## Proposal for Corrigendum 1 to Supplement 10 to Regulation No. 98

A proposal from GTB to amend Regulation 98 to incorporate LED modules was adopted and became supplement 9. Subsequently GTB submitted GRE-2007-44 which was converted to WP29-2008-31 which was adopted and became supplement 10. During the process of developing supplement 10, the provisions in annex4 were inadvertently changed and reversed the text previously agreed and adopted in supplement 9.

1. P or D or F (HC or HR or B)

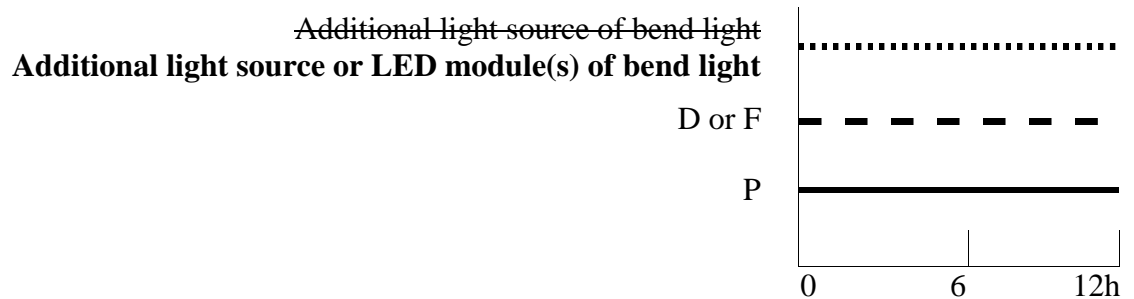
Annex4, correct to read as follows: (Corrections shown in strike-through and BOLD characters)  
 "....
